HERBATA DATA CENTRE, NAAS - RESPONSE TO REQUEST FOR FURTHER INFORMATION ("RESPONSE TO RFI") FROM KILDARE COUNTY COUNCIL

ADDENDUM TO CHAPTER 4 DESCRIPTION OF THE PROJECT AND
NEED FOR THE PROJECT

NI2615
01
June 2025

Figure 4.2: Amended Overall Proposed Site Plan (extract of now submitted drawing 22217-RKD-ZZ-ZZ-DR-A-1010-OVERALL PROPOSED SITE PLAN)

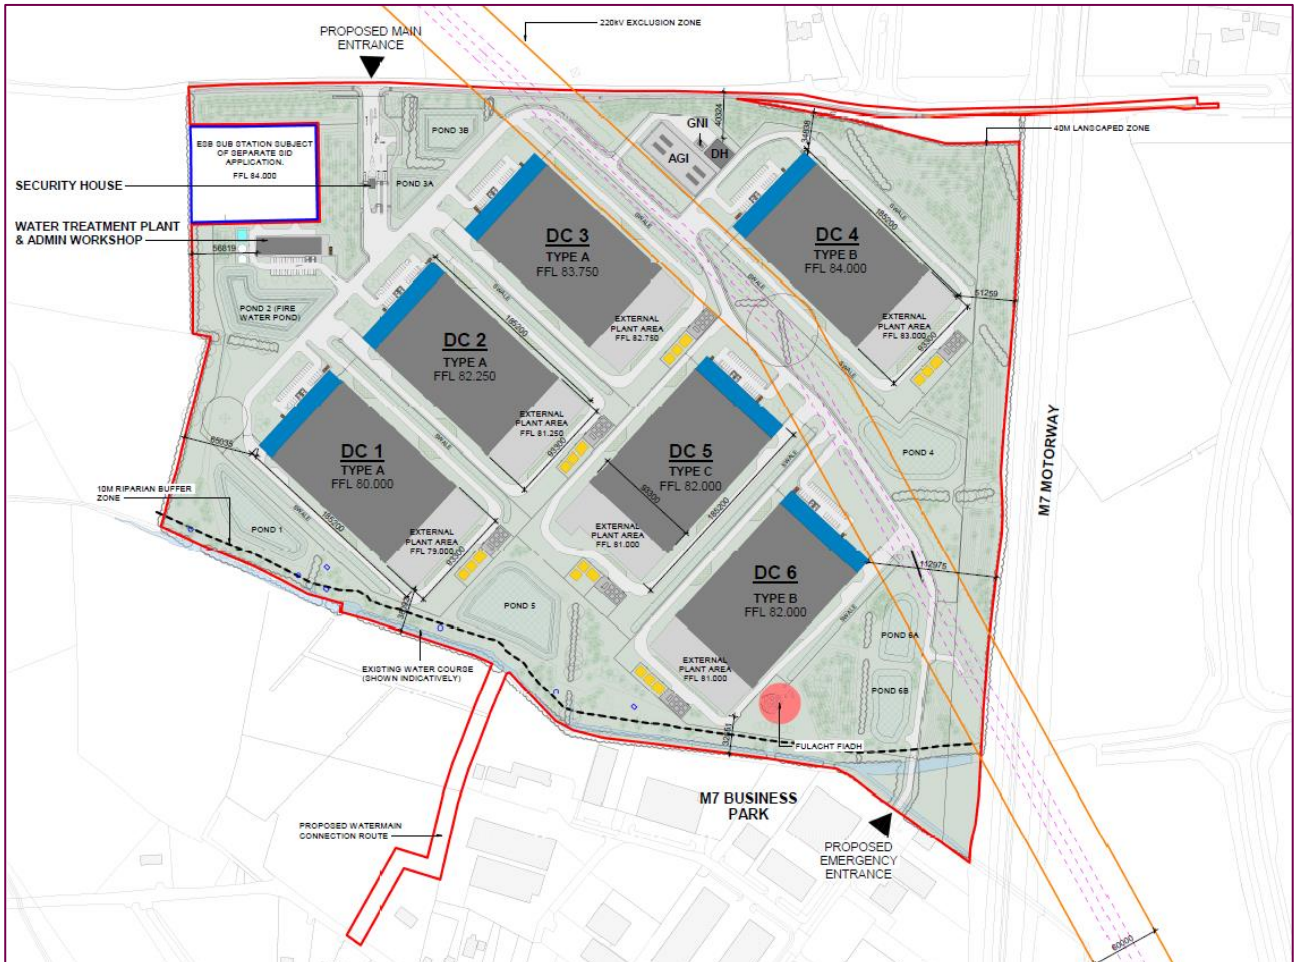
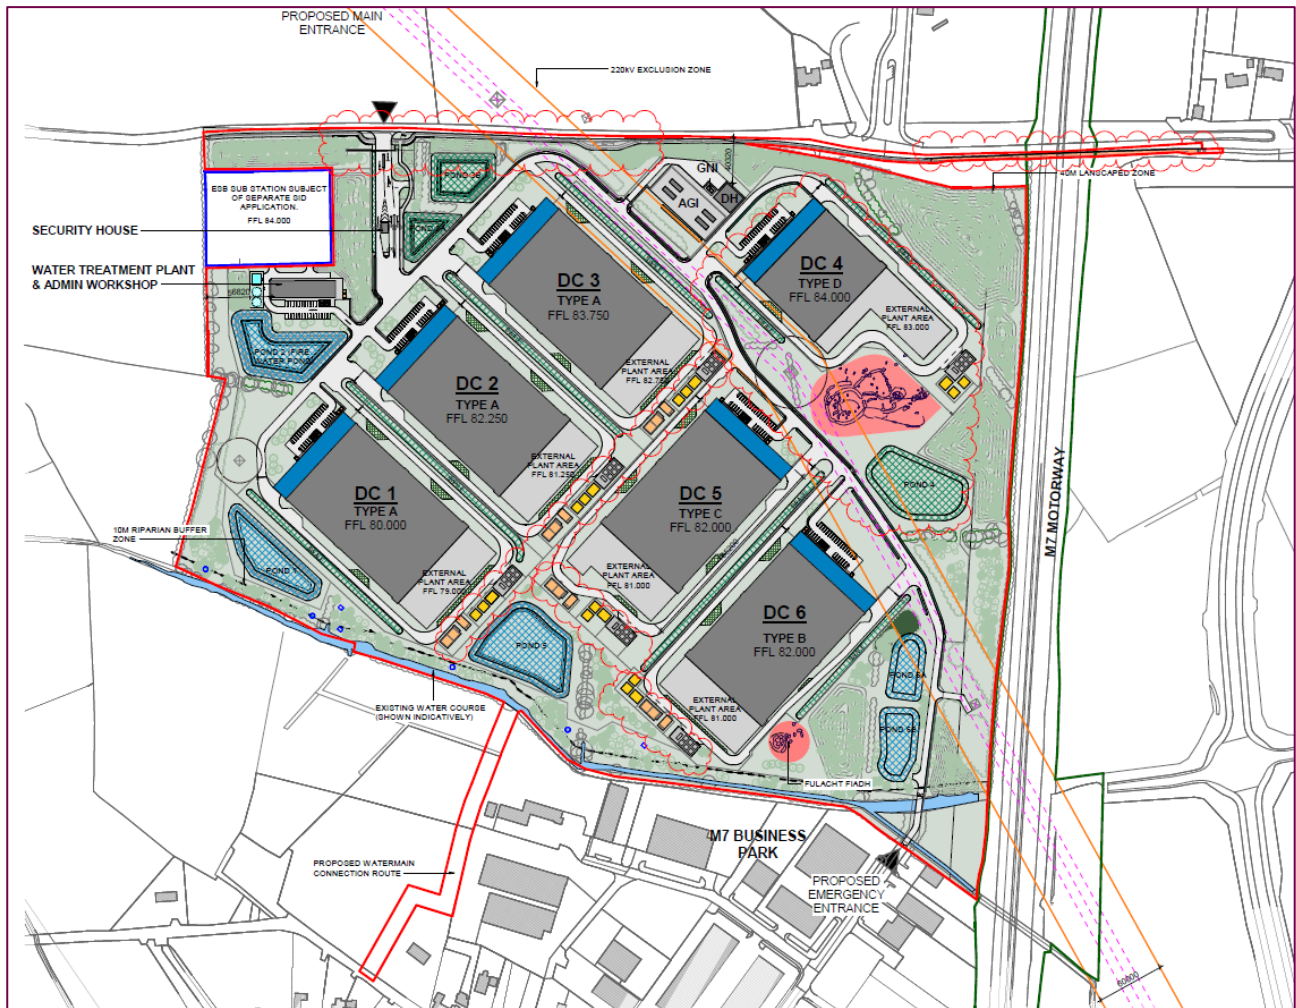
For the purpose of comparison, Figures 4.1 and 4.2 below, illustrate the previously submitted *Overall Proposed Site Plan* and (amended) proposed site context plan, respectively.

Figure 4.4: Amended Proposed Site Plan (extract of now submitted drawing 22217-RKD-ZZ-ZZ-DR-A-1012-PROPOSED SITE PLAN B)

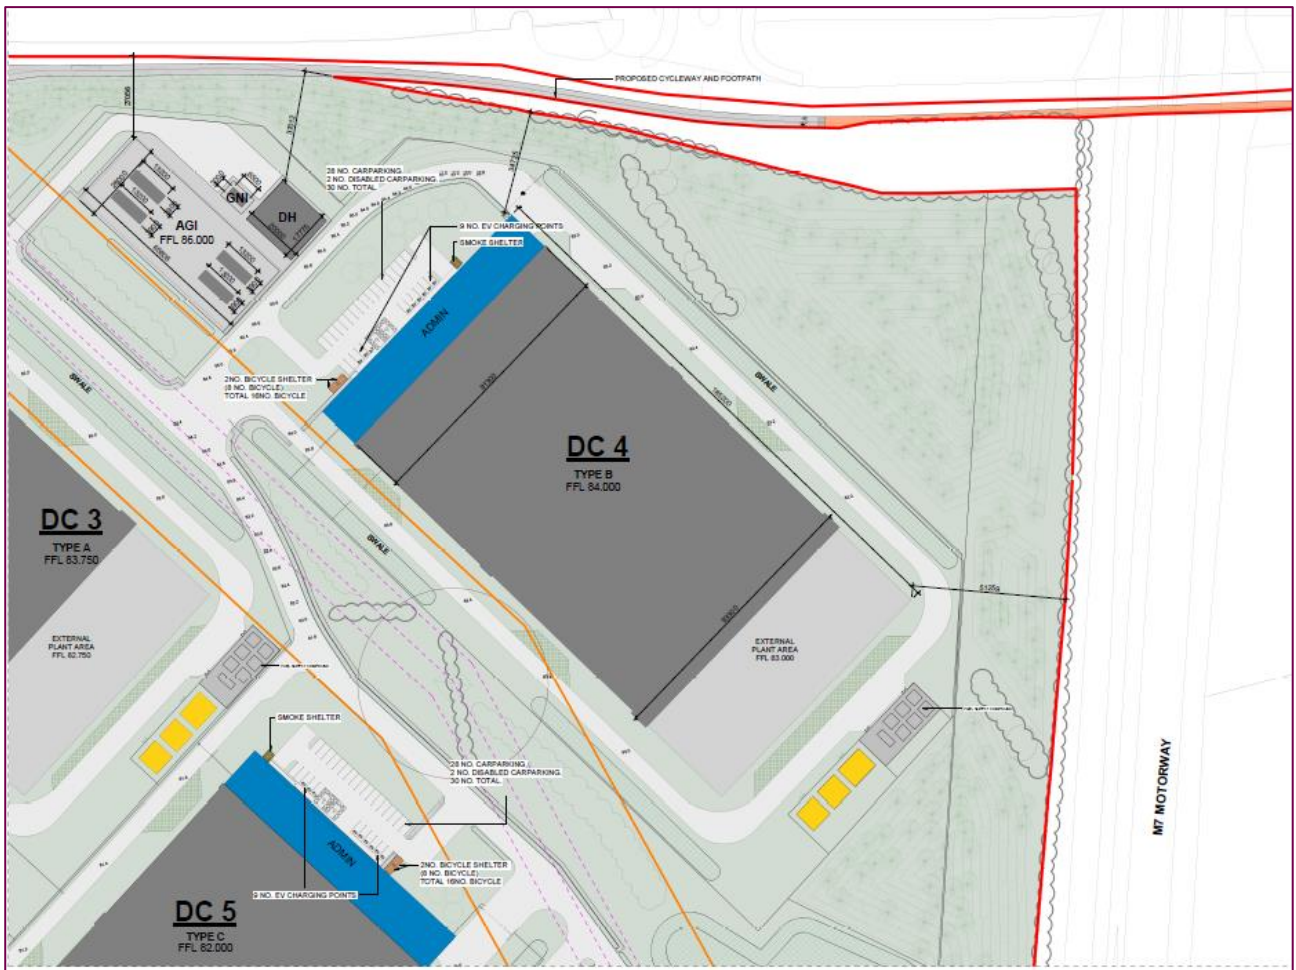
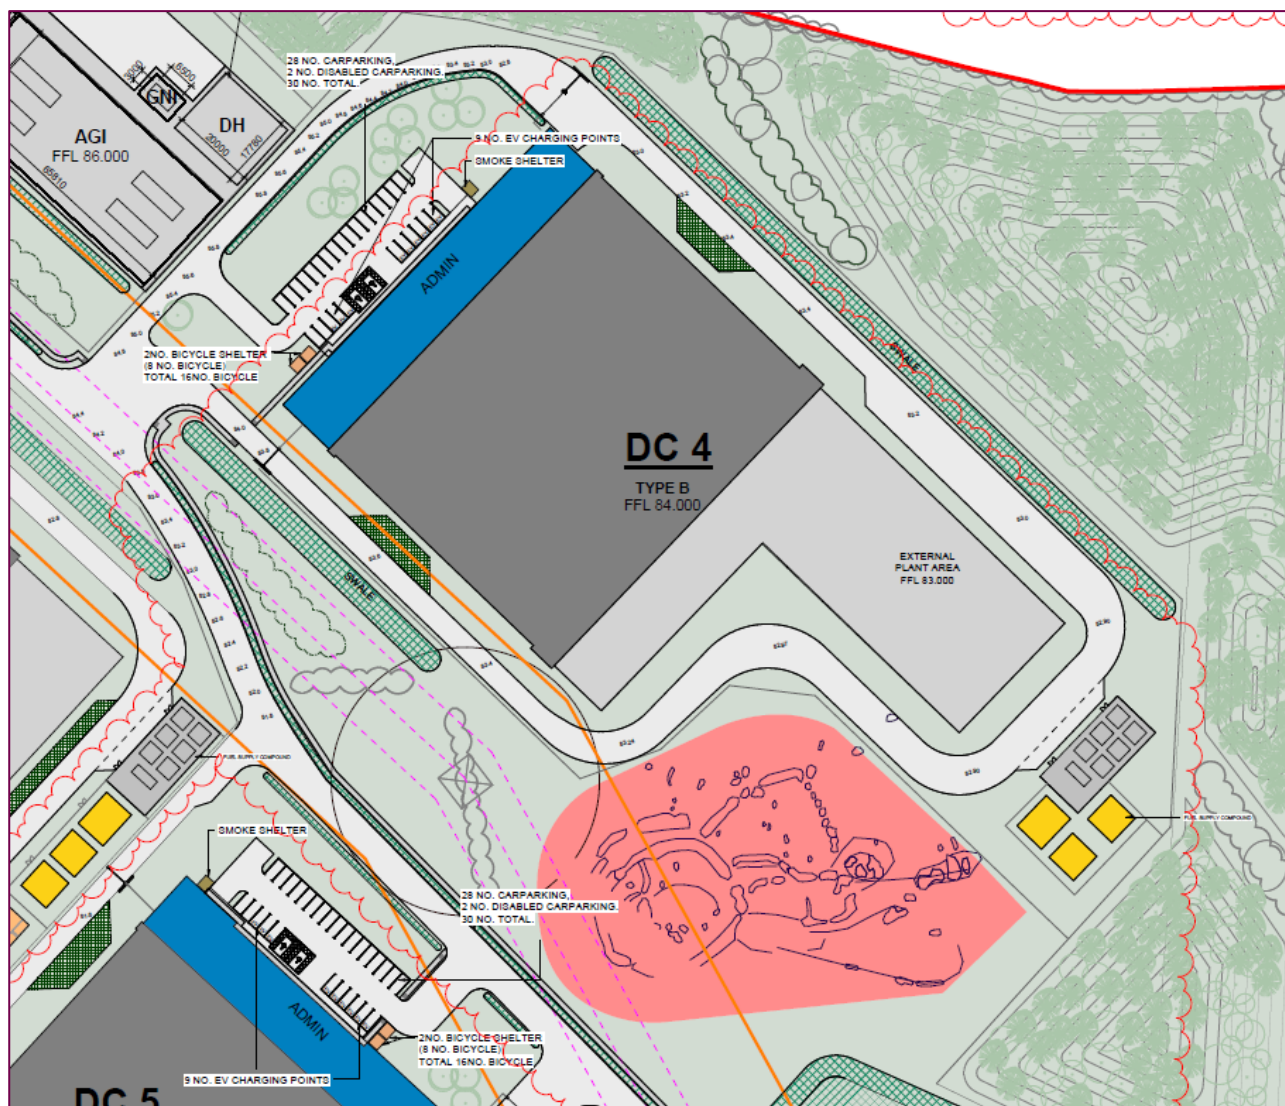
The amended design for Data Centre 4 is primarily in respect of the external plant yard (to the rear of the building) and subsequently, the overall shape of the building and an overall reduction in the area of the building.

For the purpose of comparison in respect of the amended design of Data Centre 4, Figures 4.3 and 4.4 below, illustrate the previously submitted site plan detail for Data Centre 4 and amended proposed layout detail for Data Centre 4 respectively.

- Total Area – 16,188m² (previously 27,261m²)
- Height to parapet – 18m – unchanged
- Height to flue – 19m – unchanged
- Building height - c.19m – unchanged

Figure 4.5: Ground Floor Layout Including Illustrating Building Energy Infrastructure (extract of now submitted drawing 22217-RKD-ZZ-00-DR-A-1115-DATA CENTRE - OVERALL GROUND FLOOR PLAN TYPE D)

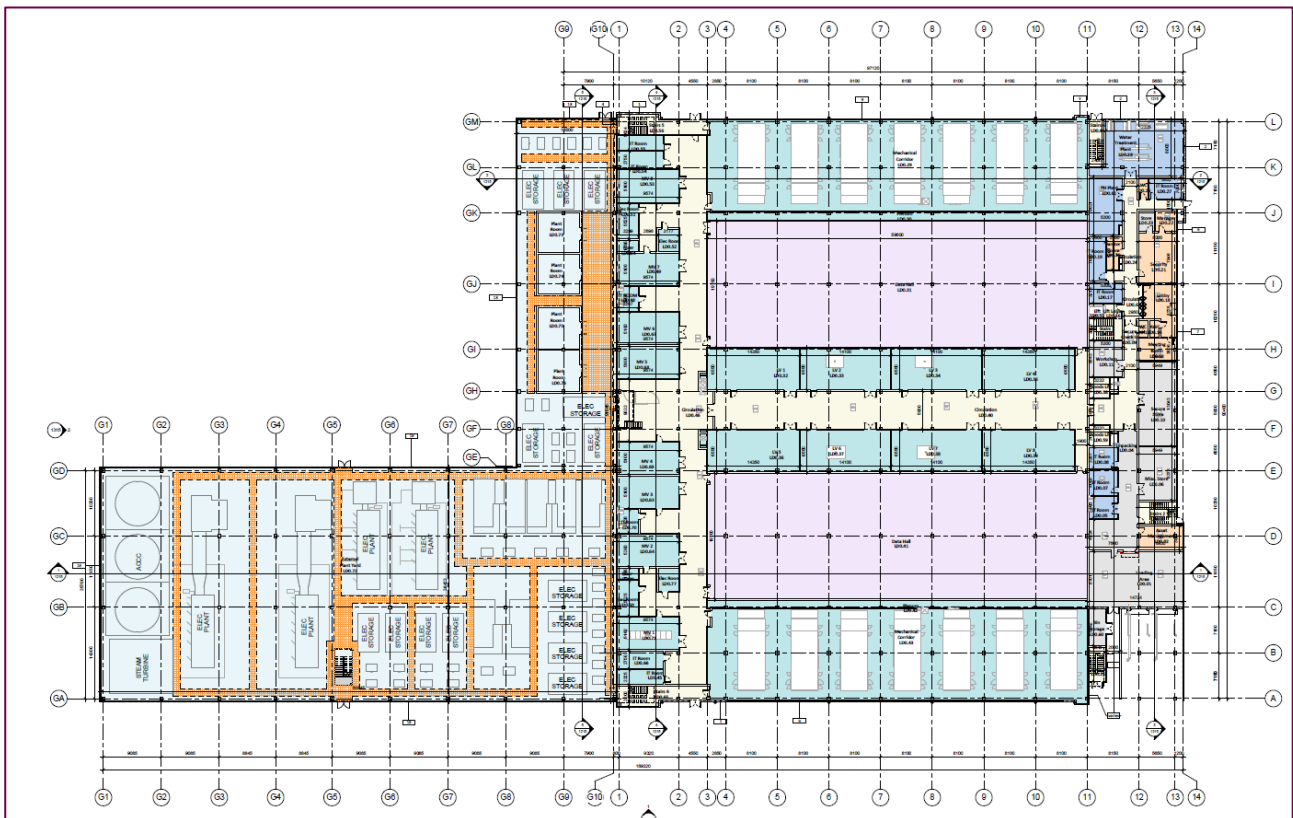
The external plant gantry and enclosed yard to the rear (encompassing the building energy infrastructure) of Data Centre 4 remains largely consistent with the description set out in the submitted EIAR however the

arrangement of the energy infrastructure has been altered to reflect the amended building design as illustrated in Figure 4.5 below.

Figure 4.6: Amended Solar PV Arrays, Data Centre 4 (extract of now submitted drawing 10360452-HDR-ZZ-02-DR-E-602003)

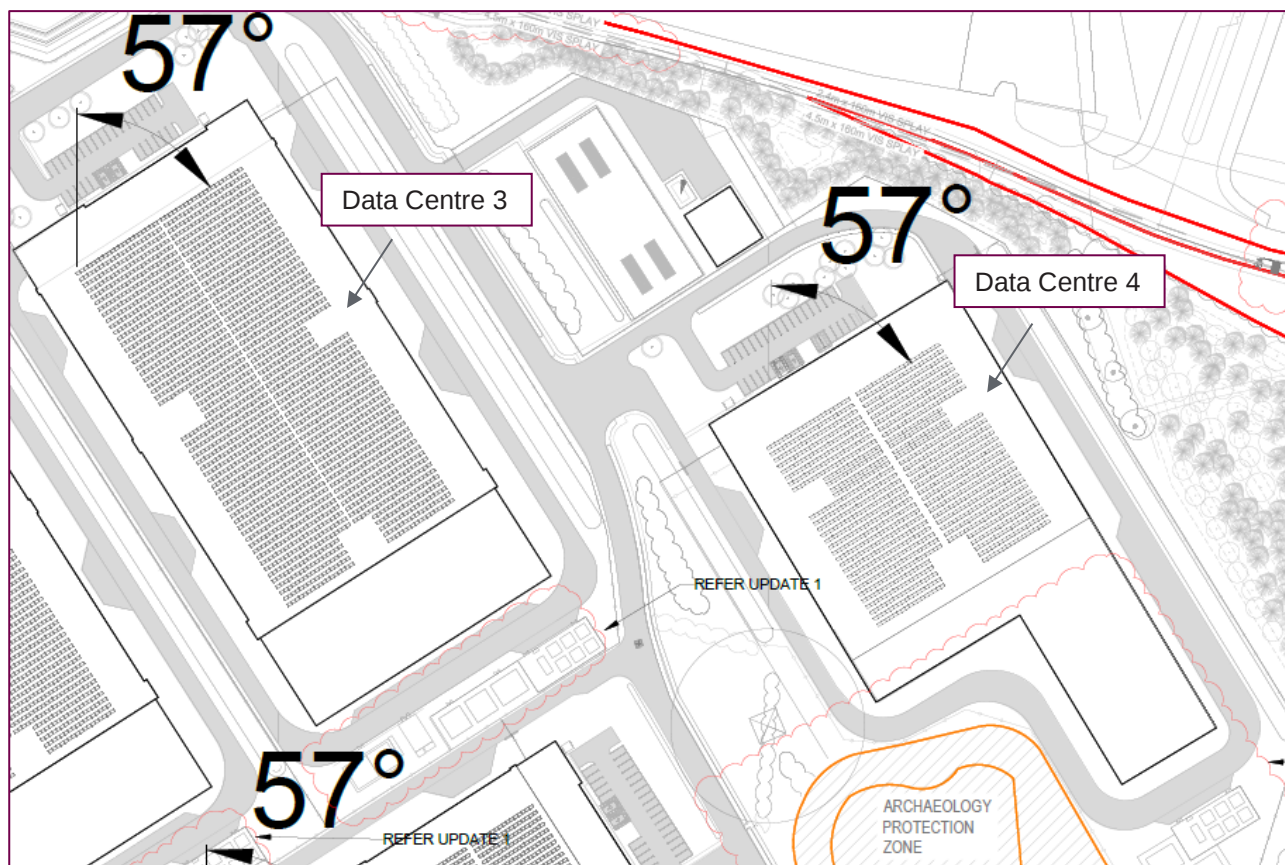
Data Centre 4 will maintain the proposed solar photovoltaic (PV) arrays, located on the roof top albeit with a reduction in the number of panels, due to the amended design of the building. The amended design of Data Centre 4 comprises solar PV arrays with an area of 1800m² whilst the remaining data centres retain the submitted area of solar PV of 3600m². Figure 4.6 below illustrates the arrangement of solar PV panels on Data Centre 4 due to the amended design in comparison to the arrangement of solar PV panels on the adjacent, Data Centre 3.

Figure 4.7: Proposed Air Cool Condensers and Steam Turbine (extract of now submitted drawing 10360452-HDR-XX-XX-DR-C-082111)

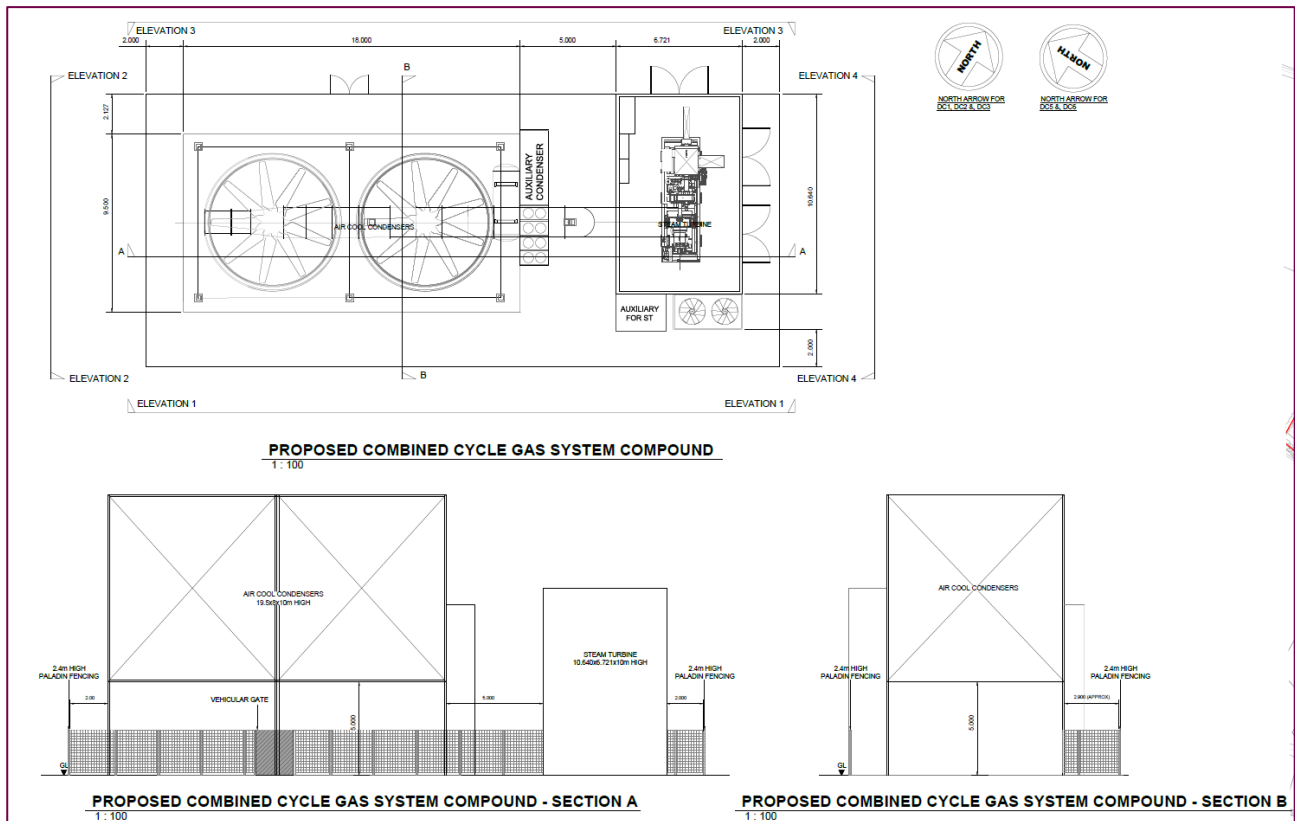
Due to the amendment to the Project Energy Strategy (as detailed further in Section 4.2.3) and specifically in respect of the proposed Combined Cycle Gas Turbines (CCGTs), amendments have been made by way of additional compounds to the rear of each Data Centres 1 - 3, 5 and 6. The amendments include the provision of air cool condensers and a steam turbine, adjacent to the fuel supply and sprinkler supply compounds (as proposed in the submitted planning application). Figure 4.7 below illustrates the layout and an elevation of the condensers and steam turbines.

Figure 4.8: Detail of Proposed R409 Improvements (extract of now submitted drawing 2232-DOB-ZZ-ZZ-DR-C-1600)

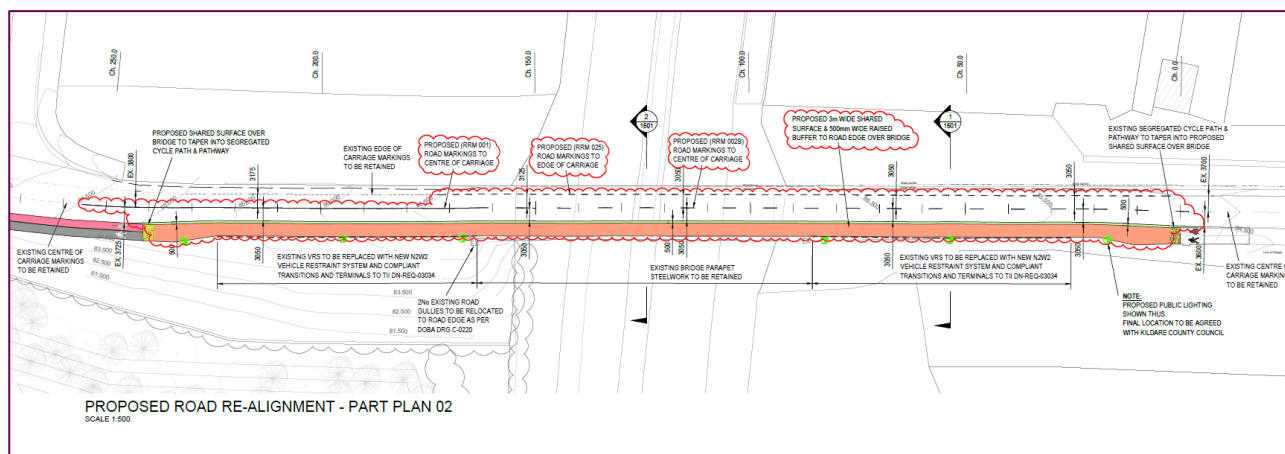
Amendments are proposed in respect of the Kildare County Council Roads Department for a footpath and cycle path as part of the proposals, along the R409 Caragh Road, which traverses the M7 motorway on an overbridge. The amendments to provide a footpath and associated line markings and replacement of the traffic barriers will be undertaken on the R409 (where it traverses the M7 motorway) are detailed in the now submitted drawing 2232-DOB-ZZ-ZZ-DR-C-1600 PROPOSED R409 ROAD VRU IMPROVEMENTS.

The proposed amendments comprise of the provision of a 3m shared surface (with a 500mm buffer) across the bridge and a reduction in the carriageway width from 7.8m to 6.1m, across the bridge; by comparison, the submitted application proposed a 2m shared surface (with no buffer).

Figure 4.9: Landscape Proposals Relative to Amended Design of Data Centre 4 (extract of now submitted drawing BSM-ZZ-ZZ-DR-L-0301)

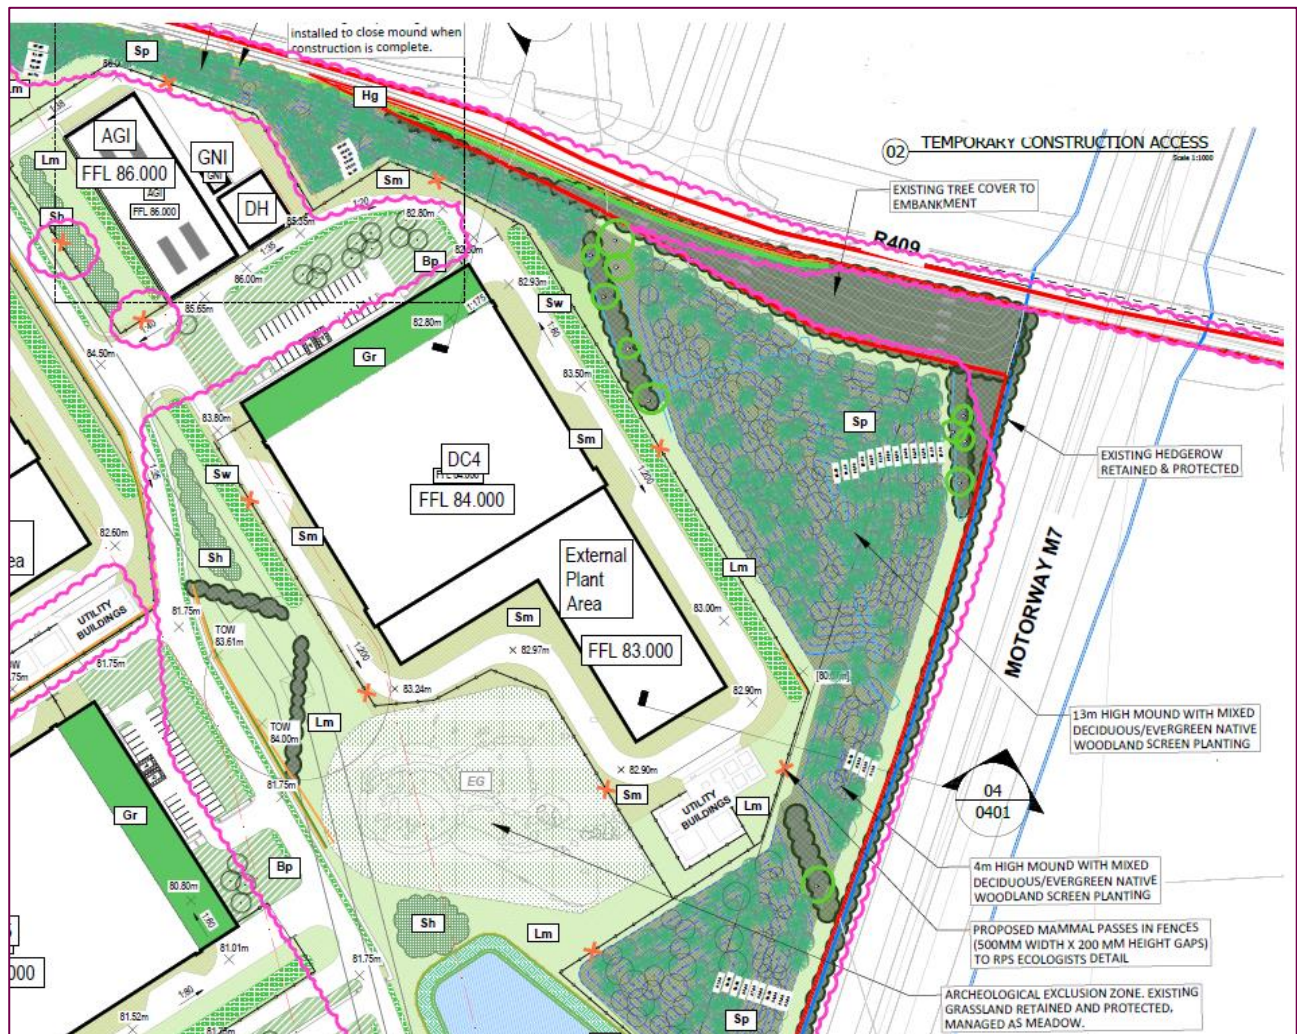
The amended design for Data Centre 4 has resulted in some minor amendments to landscape proposals within the immediate vicinity of the building; these however are minor in nature and do not alter the proposals as submitted in respect of retention of existing vegetation, proposed mounding and landscape planting along the site boundaries.

There have been a number of other minor amendments within wider the site, which have been updated in the landscape design drawings; these relatively minor amendments do not however significantly change the landscape proposals along the site boundaries. Figure 4.9 (extract from landscape masterplan, drawing number BSM-ZZ-ZZ-DR-L-0301) below illustrates the landscape proposals, relative to amended design of Data Centre 4.
